4-069-0296A

Re: Cross-Tie Phase II, Permit Application No. 4-069-0296A

RE: Cross-Tie Ranch Phase II, Application No. 4-069-0296A
Lake County, Florida (FBA #921088.001)

Re: Cross-Tie Ranch Phase II; Application Number 4-069-0296A
(Please reference the above number on any submittal)

**AS-BUILT SURVEY OF S.M.A. NO. 2
 CROSS-TIE RANCH
 PHASE II**

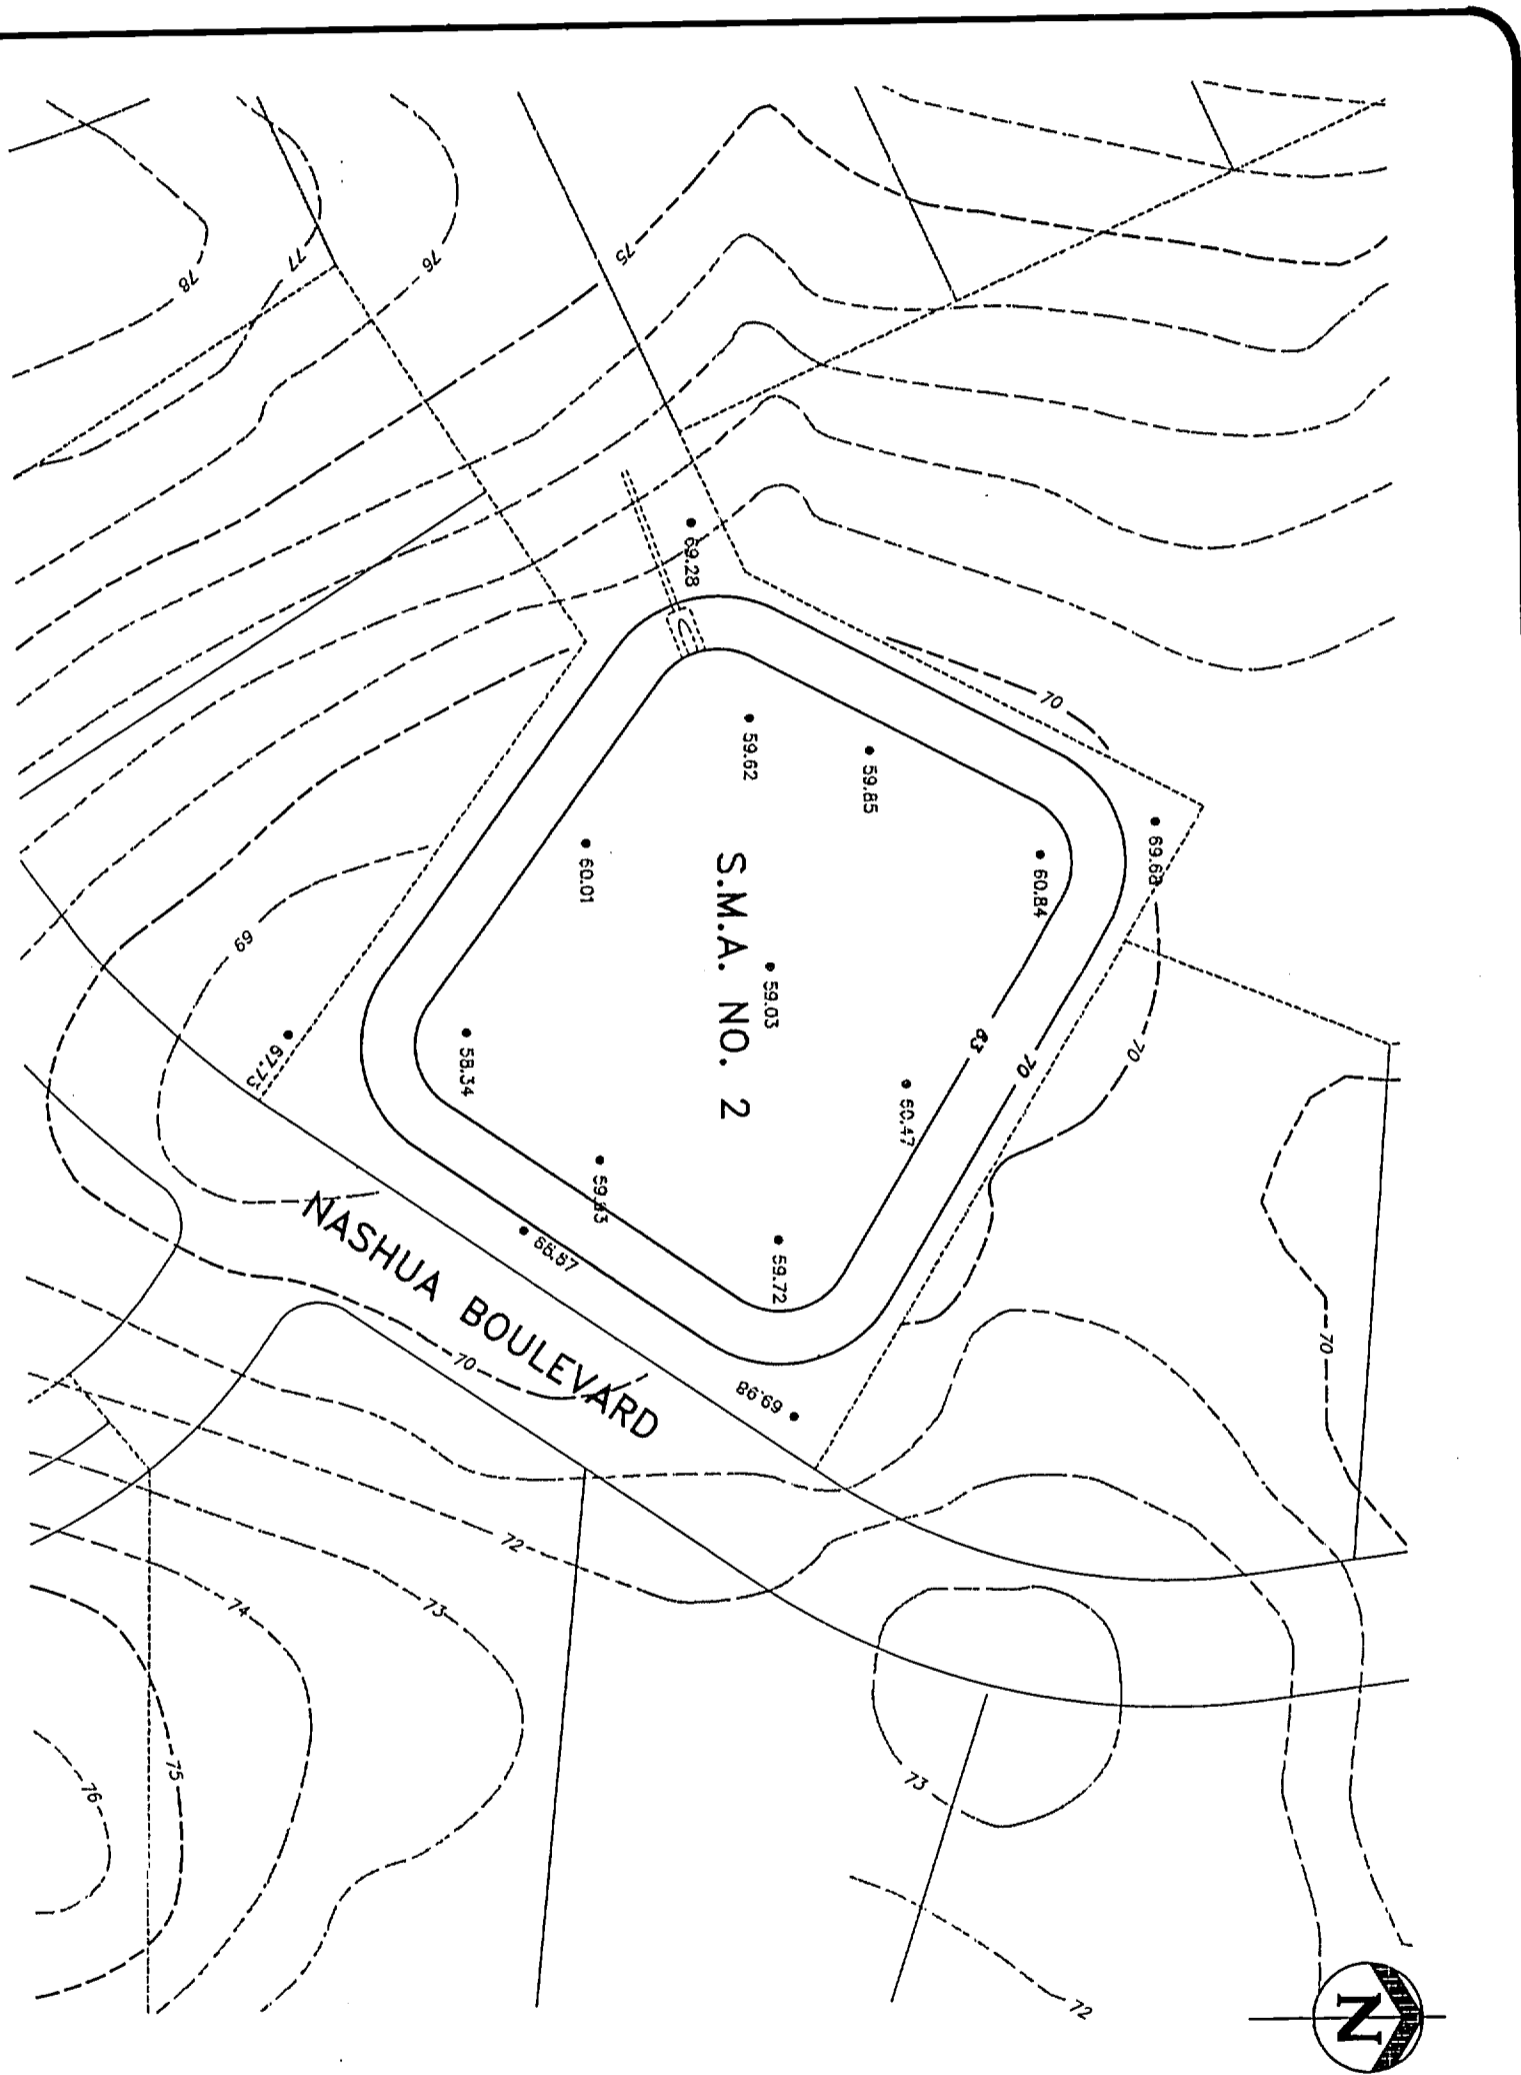
1. It appears that the project is in the Wekiva River Protection Area. Please submit a completed and executed District Form No. 40C-41.063(4) entitled "Local Government Notification" for this project. [40C-41.063(4), F.A.C.]
2. It appears that the stage-storage relationship for Pond 2 indicated in the stormwater calculations received on January 24, 1994 is inconsistent with the permitted plans for Phase I. Please clarify this discrepancy. If the pond is proposed to be reconfigured and/or deepened in Phase II, please provide a proposed cross-section. [40C-4.301(1)(a) 6., 8., 9., 10., 12.; (2)(a) 1., 2., 3., 4.; F.A.C.]

1. The completed "Local Government Form" is included.
2. The retention area SMA 2 was in fact reconfigured as part of Phase I and attached to this submittal is an "as-built" survey. The existing geometry was used in the current calculations and exceeds the previous volumes.
